Parramatta Powerhouse EIS

Flood Risk Review

Powerhouse Museum Alliance

Molino Stewart Pty Ltd

Figure 1: Stormwater Catchments and Pipes

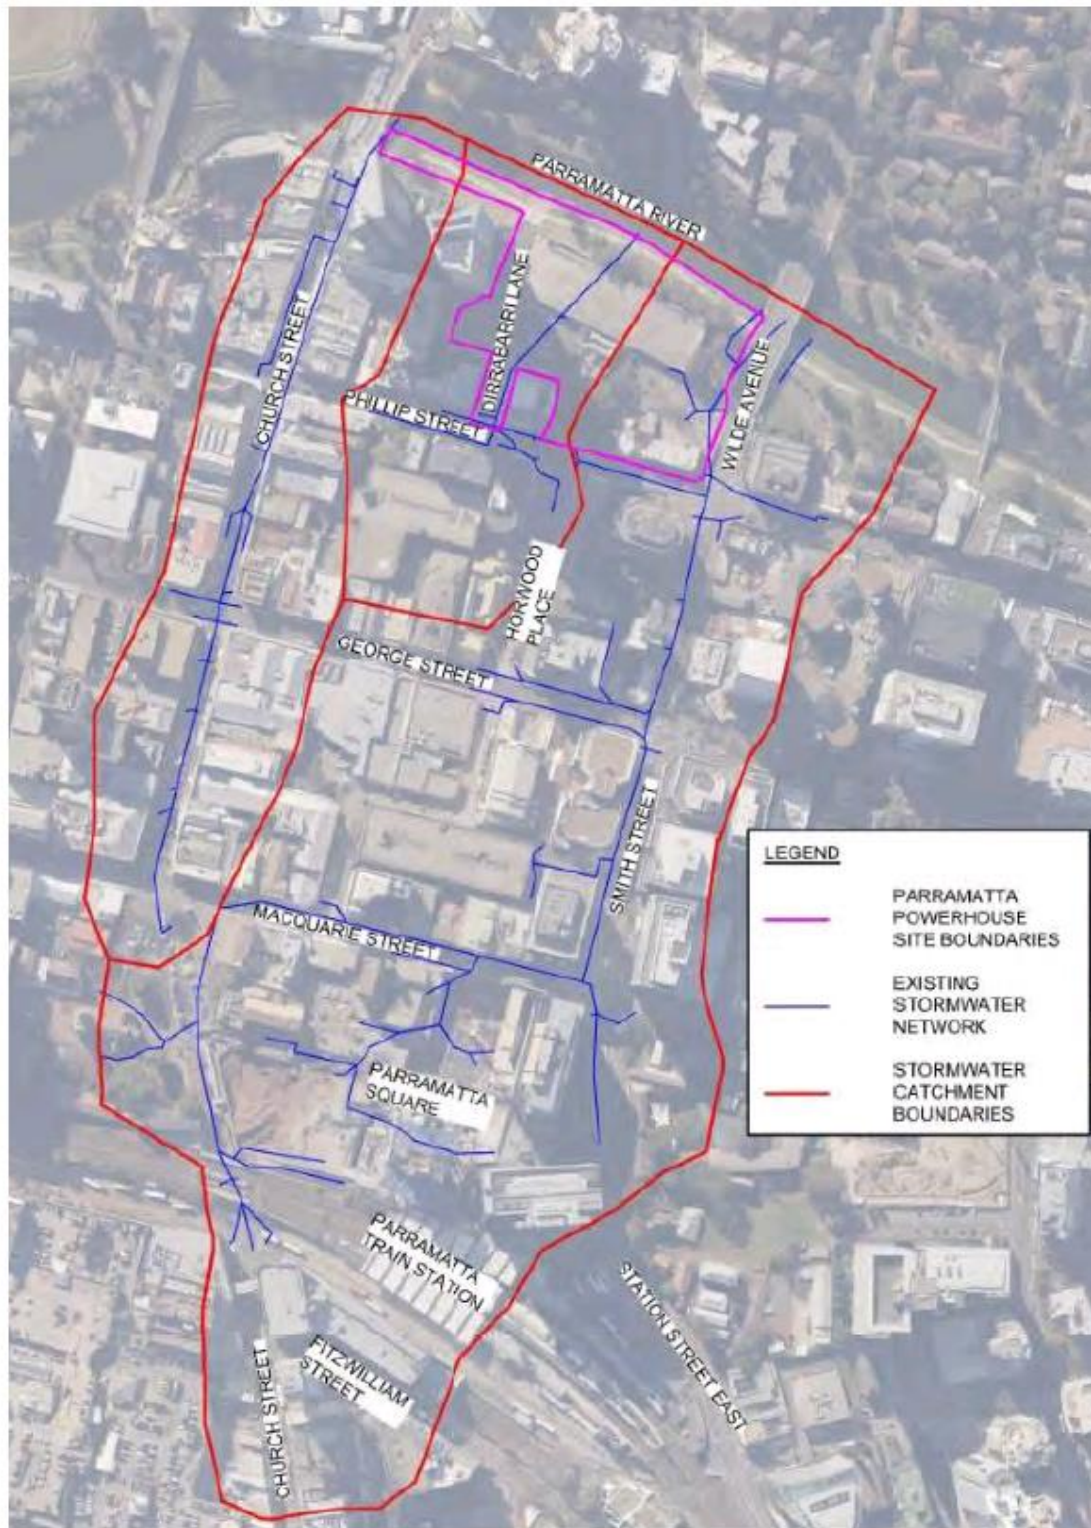
What Appendix O does not provide is a comparison between the overland flood levels in Council's two models and those in the Arup model and yet it is Arup's overland flood levels which have been used for determining the ground floor level for the building.

It is noted that Appendix O includes a flood certificate from CoPC which covers the site and provides flood levels for selected cross sections. All of the listed cross sections are along the river and none are for the model cross sections in Phillip Street or Dirrabarri Lane.

Furthermore, an important consideration in overland flow modelling is the assumed blockage of pipes and inlet structures. Appendix O claims to have included appropriate blockage factors for stormwater pits in the flood modelling but does not state what those factors are.

It is my understanding that CoPC adopts a 100% blockage factor in its overland flood modelling which is certainly not what Arup has adopted and in this regard the Arup modelling is not consistent with Council's overland flood modelling approach. The criticality of this is discussed in more detail in Section 3.2. It is my opinion that detailed design must be based on Council's new flood model or one which is calibrated to it.

Figure 2: Comparison of flood model results

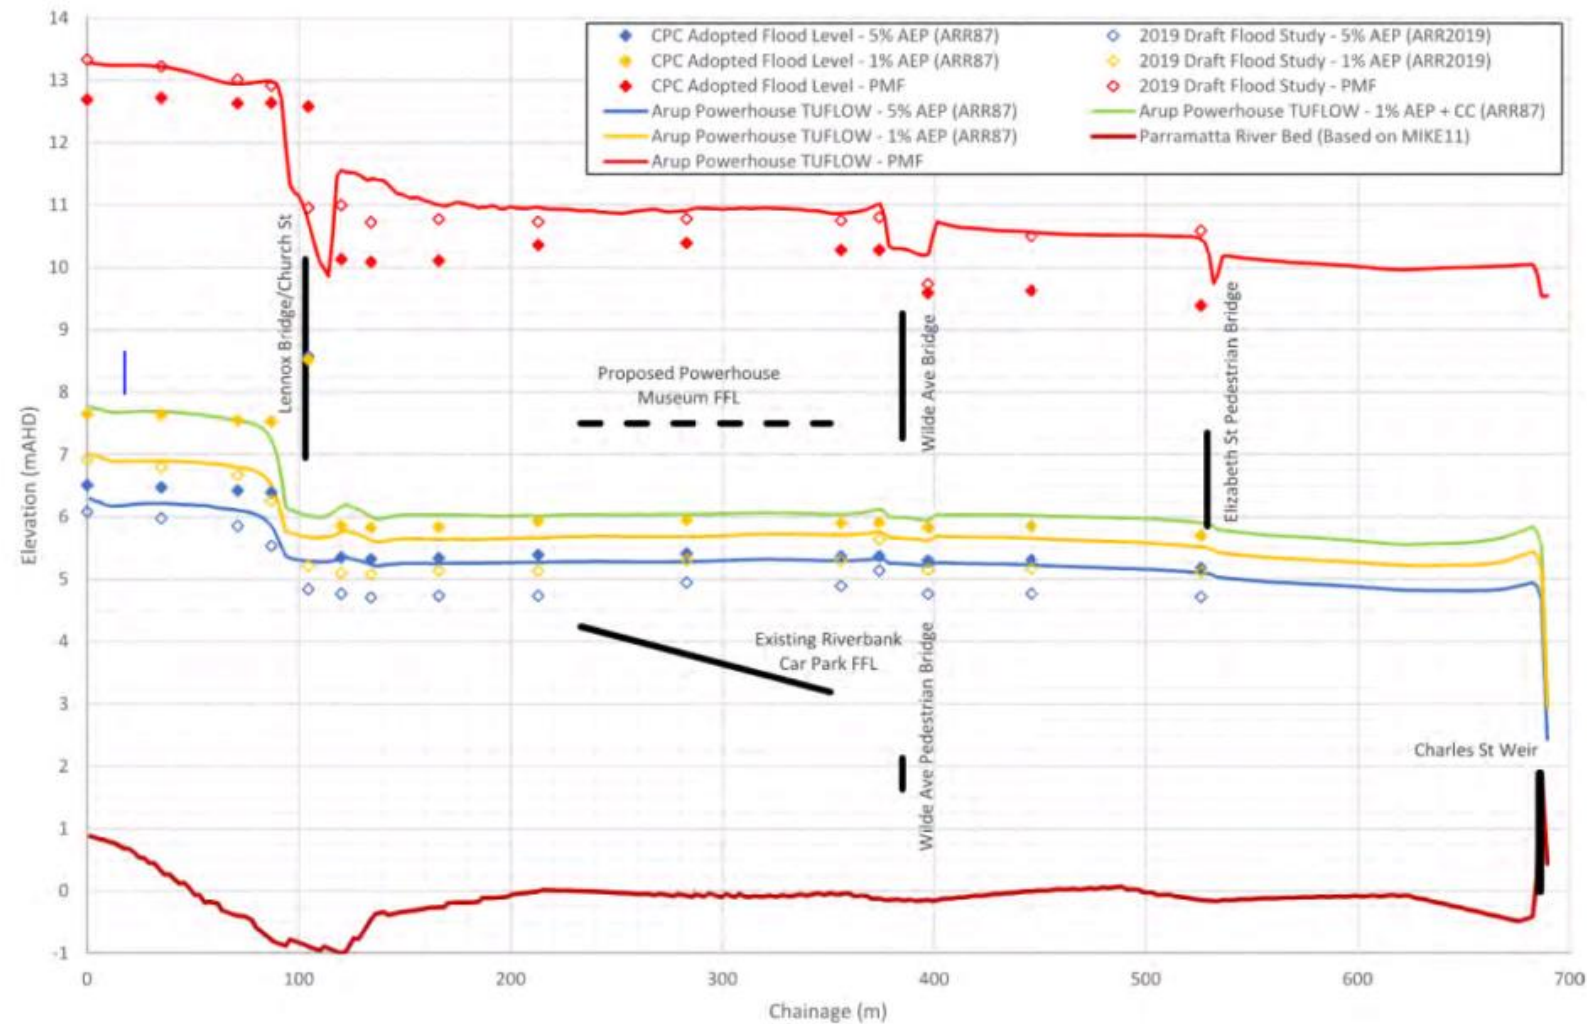
While the Arup levels differ from those of the other two models, the differences between all three models in the vicinity of the museum site are generally less than 0.5m. Furthermore, the riverine flood levels are lower than the overland flood levels up to the 1% AEP and therefore the accuracy of the riverine flood levels are not critical to the design of the building and any flood emergency response measures. Accordingly, it is my opinion that the Arup model and its results are suitable for use as an interim tool for providing indicative flood information for the site, the museum design and impact assessments in relation to riverine flooding until Council's contemporary flood model has been adopted.

Figure 6: Undercroft Flood Spaces

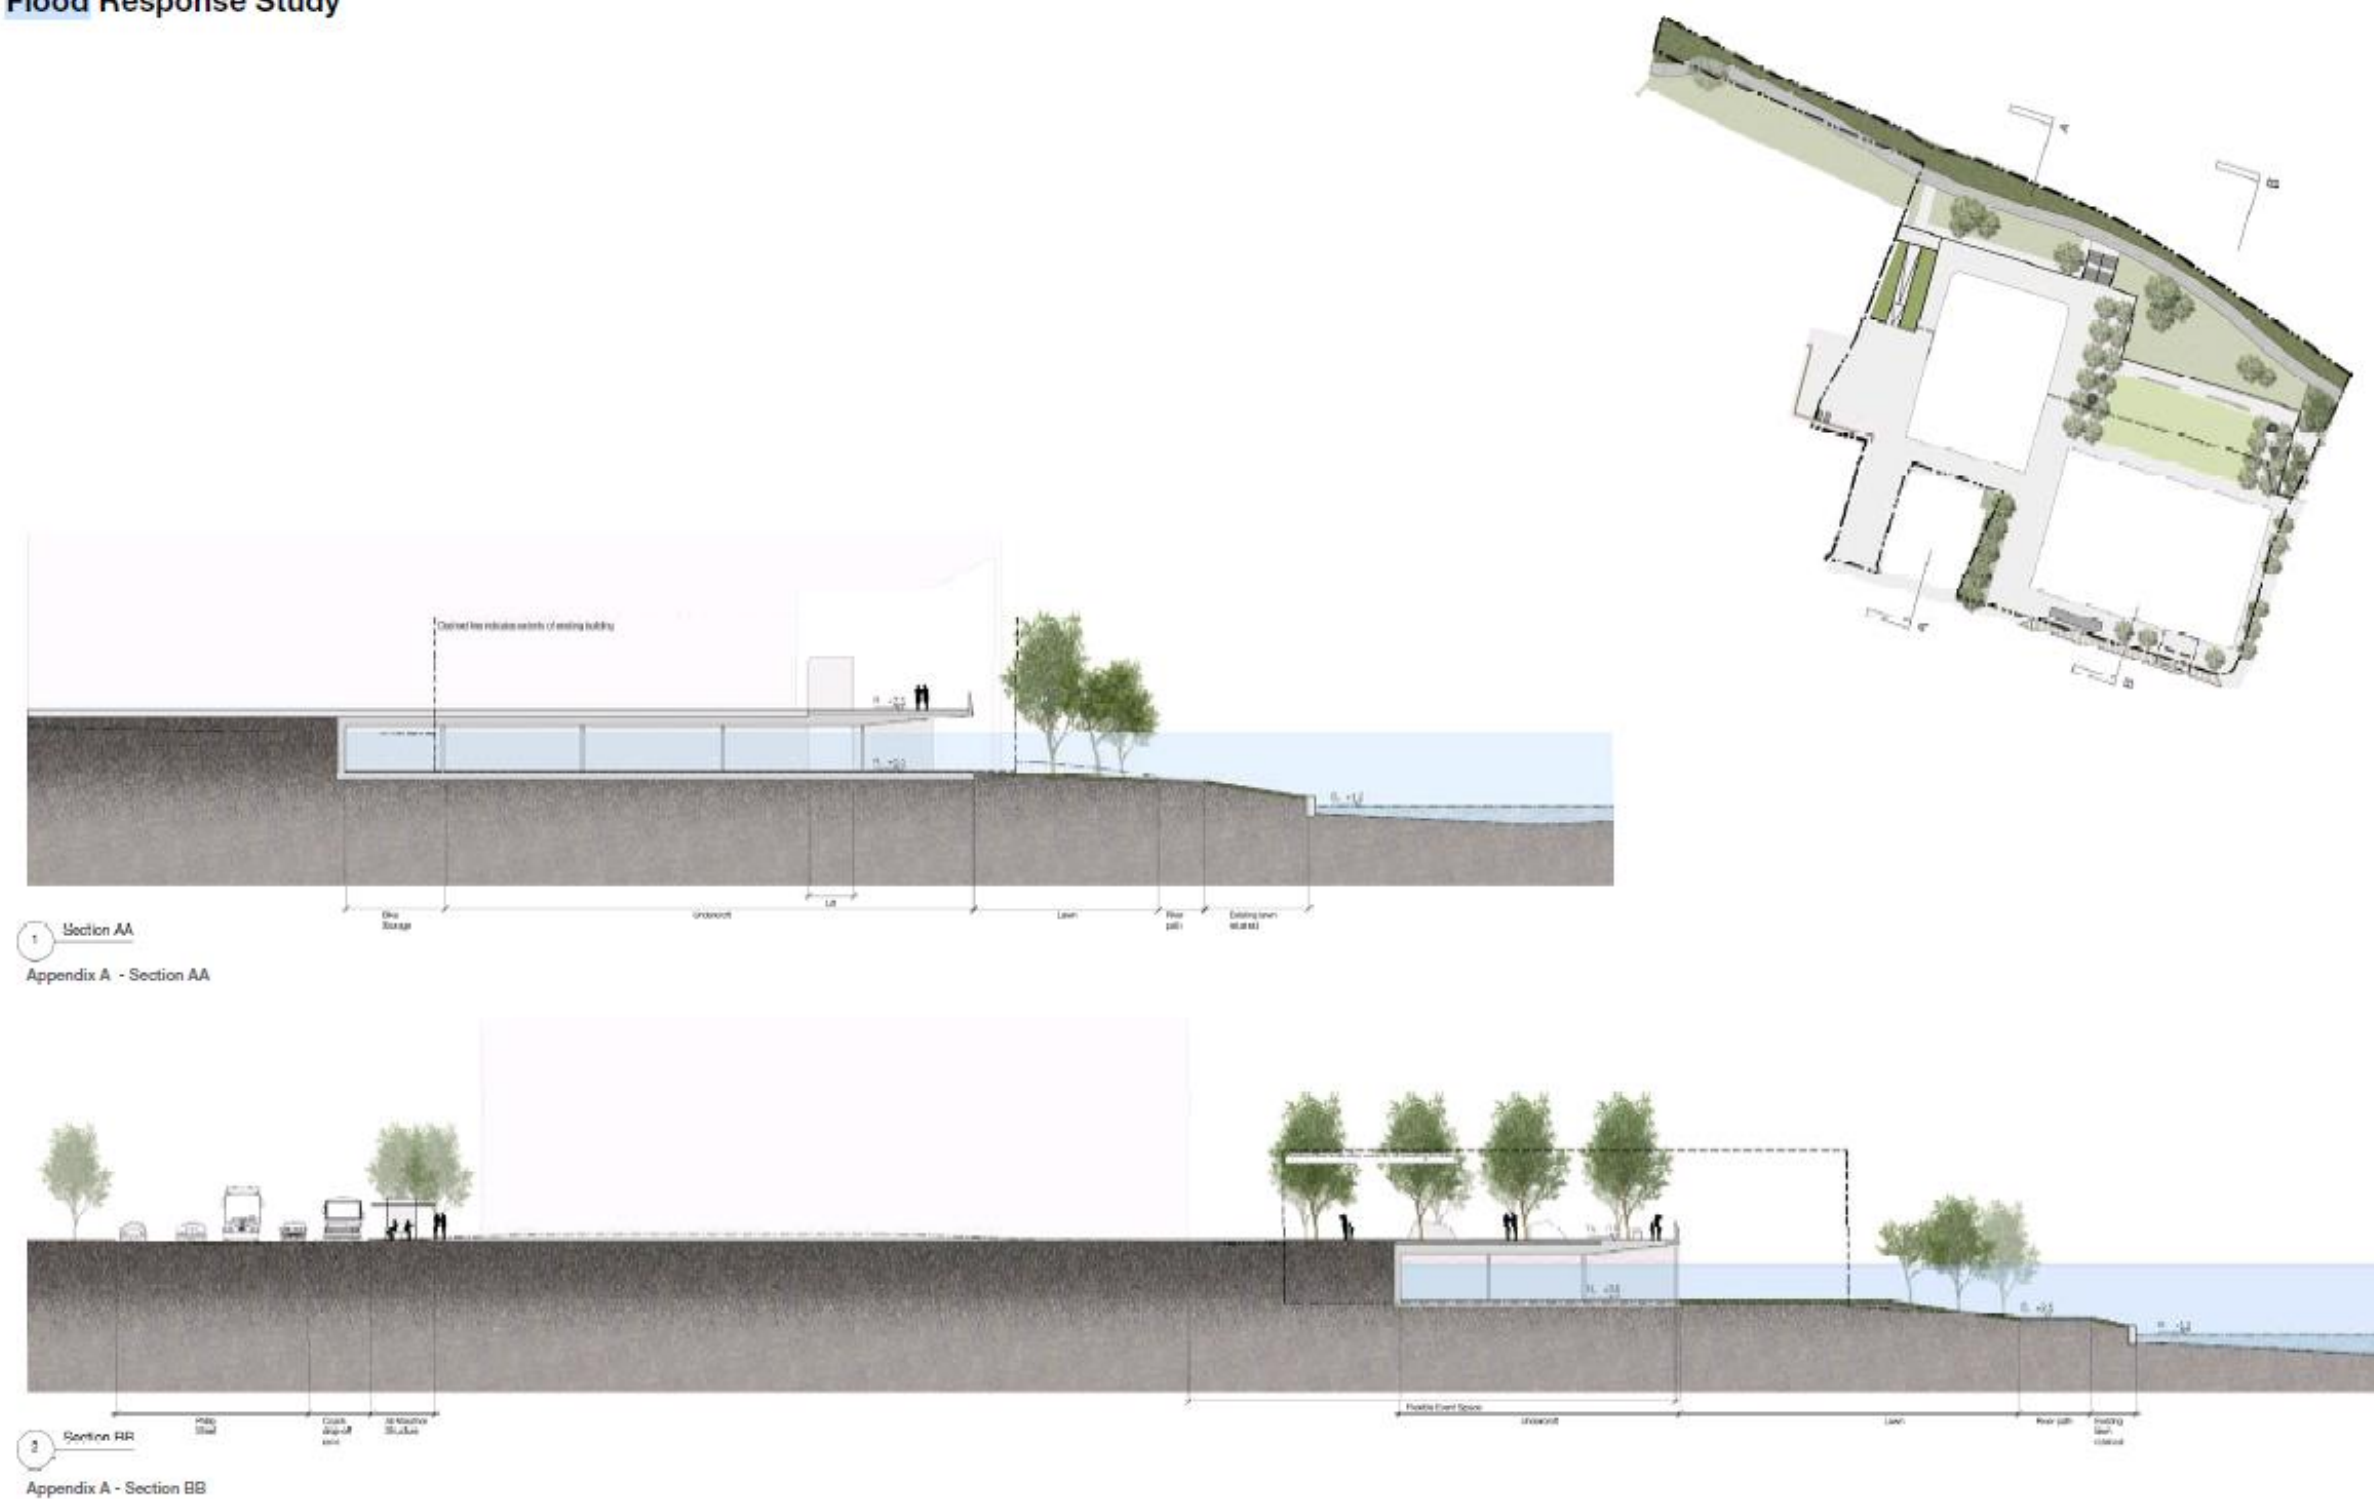
While the undercroft spaces are designed to ensure the development does not increase flood levels in the Parramatta River in the 1% AEP flood, they may present a serious flood risk to life.

It is quite reasonable to expect that during inclement weather, museum patrons, or more likely, members of the public could take shelter in the undercroft areas. However, as shown in Figure 9, there are two problems in leaving these shelters once flooding commences.

The first is that it is necessary to walk down towards the river before being able to walk up to flood free ground.

The second is that the routes up are designed as overland flow paths.

People sheltering within these spaces may not appreciate just how high and how quickly the river can rise and they become entrapments in which people drown or they drown trying to leave them.
